SKILLING, HELLE, CHRISTIANSEN, ROBERTSON — Structural & Civil Engineers

PROJECT THE WORLD TRADE CENTER | TITLE FLOOR TRUSS DETAIL 10B - REPAIR | DATE 5/11/70

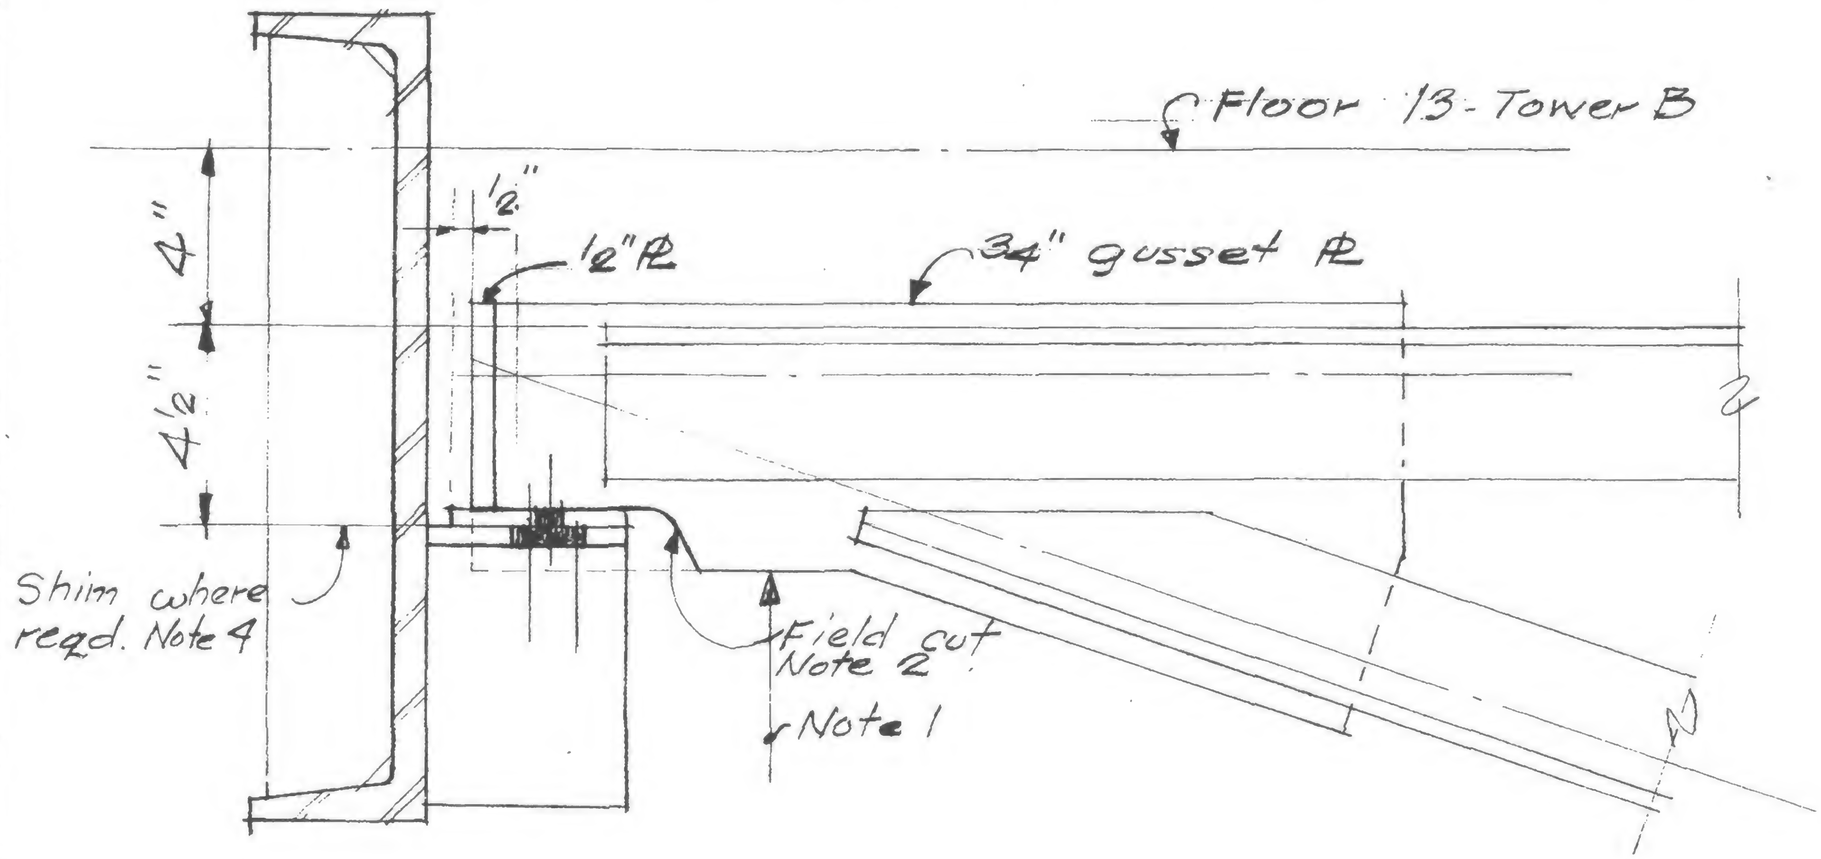
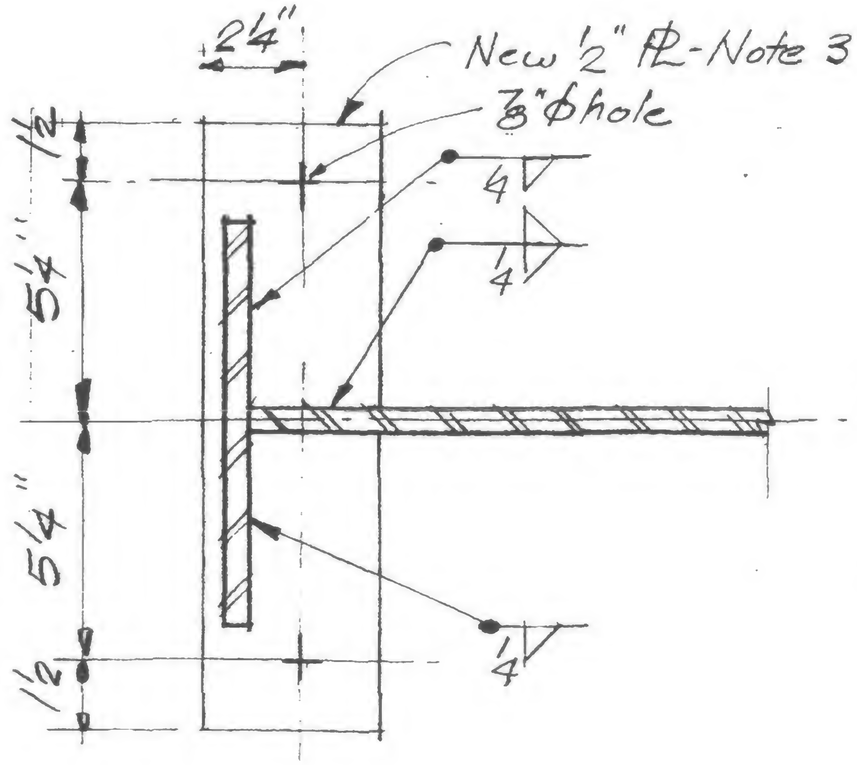
1. Shore truss for 5 kips.
2. Cut 34" gusset PL of truss and ½" end PL of truss as shown.
3. Provide new ½" PL and weld as shown.
4. Provide shim stock as required.
5. Lower truss end 1½".
